Product Change Notice (PCN)

PCN Number: PCN-0456167R-01

Product(s) Affected: PJ-014CH-SMT-TR

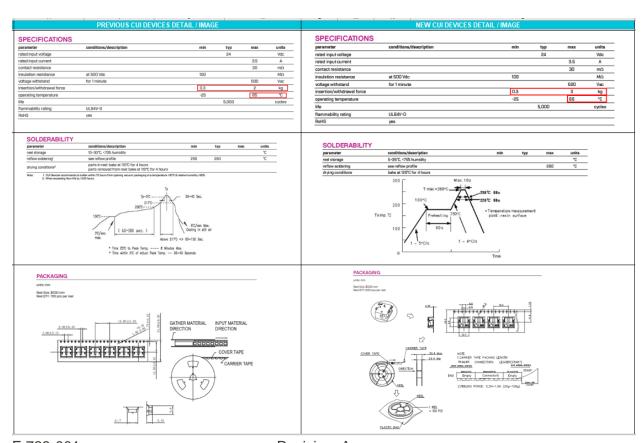
Description of Change: Product re-engineered for improved manufacturability and production yield. See image below for product changes. Cosmetic differences may be visible and not affect the form fit and function of the product. Please refer to updated drawing on the website for the updated specifications.

PREVIOUS CUI DEVICES DETAIL / IMAGE		
PREVIOUS CUI DEVICES DETAIL / IMAGE		NEW CUI DEVICES DETAIL / IMAG
DESCRIPTION MATERIAL PLATING/COLOR center pin brass silver terminal 1 brass = 0.50 silver terminal 2 bronze t=0.25 silver	DESCRIPTION center pin terminal 1 terminal 2	N MATERIAL PLATING/COLOR brass CuSh brass =0.30 silver prospenor profess and silver silver silver
terminal 3 brass <mark>t=0.50</mark> silver	terminal 3	brass t=0.30 silver
housing PA10T (UL94V-0) black	housing	PA10T (UL94V-0) black
MATING PLUG Jack Insertion Depth: <mark>5.9 mm</mark>		MATING PLUG Jack Insertion Depth: 6.1 mm
